Santa Clara Valley Water District
Notification of this Addendum is transmitted via email to all current plan holders.
This Addendum is posted on the Valley Water website at
<https://www.valleywater.org/construction>

June 1, 2021

ADDENDUM NO. 1
TO CONTRACT DOCUMENTS FOR THE
RINCONADA WATER TREATMENT PLANT (RWTP)
RESIDUALS REMEDIATION PROJECT
Project No. 93294058 Contract No. C0671

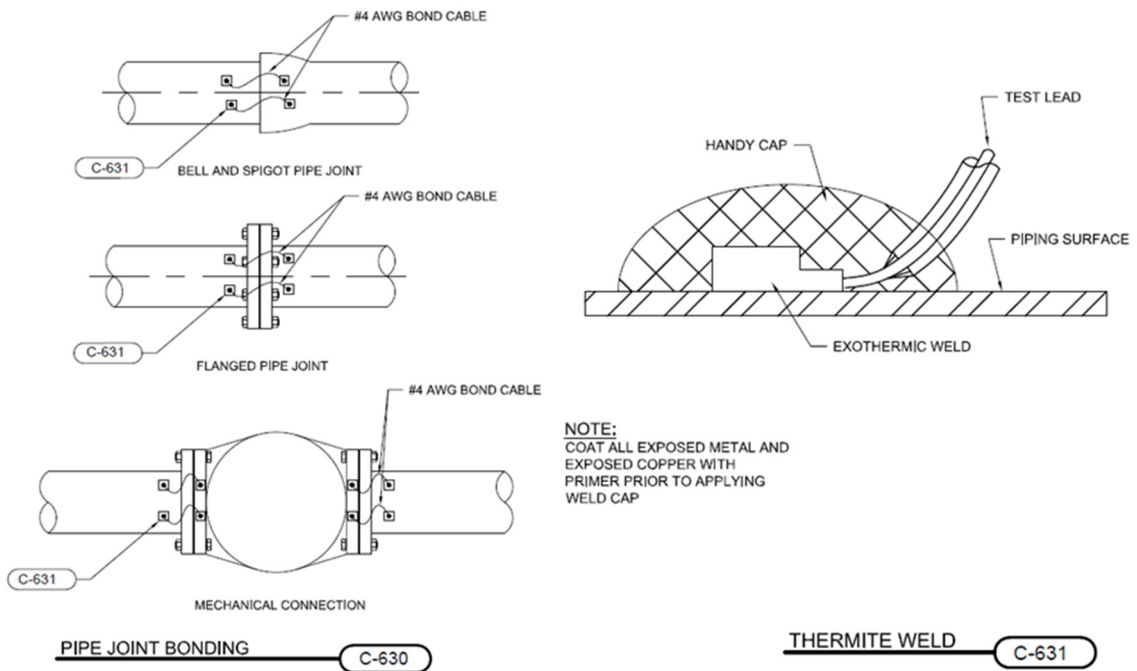
Specification section 33 92 20 Ductile Iron Piping 2.01 "G" states "Pipe joints shall be prepared for bonding electrical conductivity in accordance with the details indicated. Contractor Shall furnish materials required for joint bonding and electrolysis test station installations." Specification section 40 05 00 Paragraph 2.09 says metallic buried piping shall have bonded joints so that it may be cathodically protected in the future if necessary." Please clarify whether we need cathodic protection as the drawings do not call out any cathodic test stations. If so, please provide a detail and confirm that only jumpers are required at buried ductile joints for bonding.

Electrically bonded joints shall be provided per Standard Details C-630 and C-631 below. Cathodic protection is not required.
